Service Bulletin

CapstanAG Valve Service Procedure

The new valve design requires new service details.

Figure 1

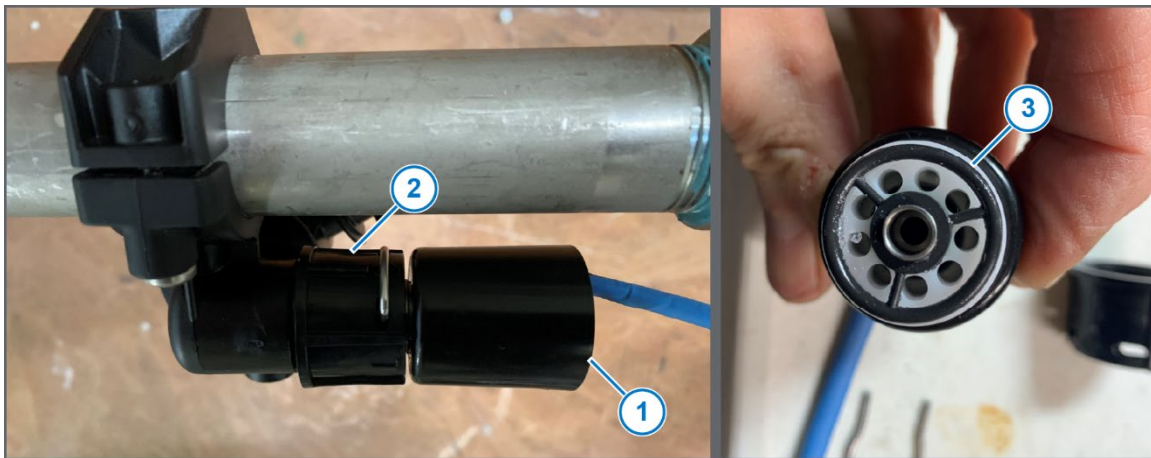
Figure 1: Hold the coil (1) stationary while tightening the flynut (2). If the coil is rotated while tightening the flynut, damage to the spoke O-ring (3) can occur and cause the valve to leak.

Figure 2

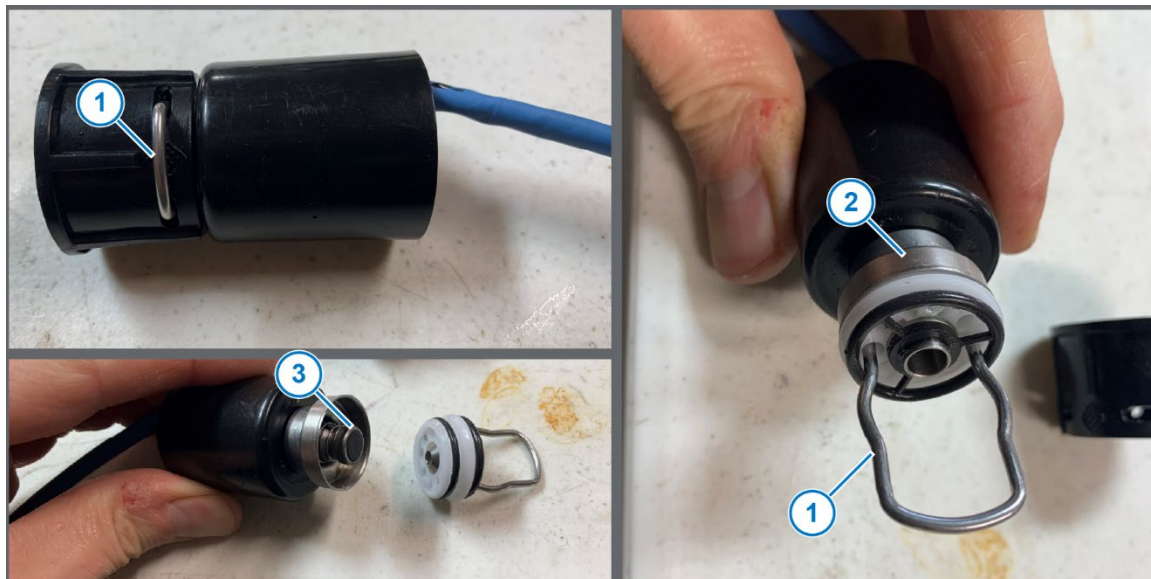
Figure 2: To service the valve components, remove the retaining clip (1). Use the retaining clip to remove the orifice insert (2) to service the plunger (3).
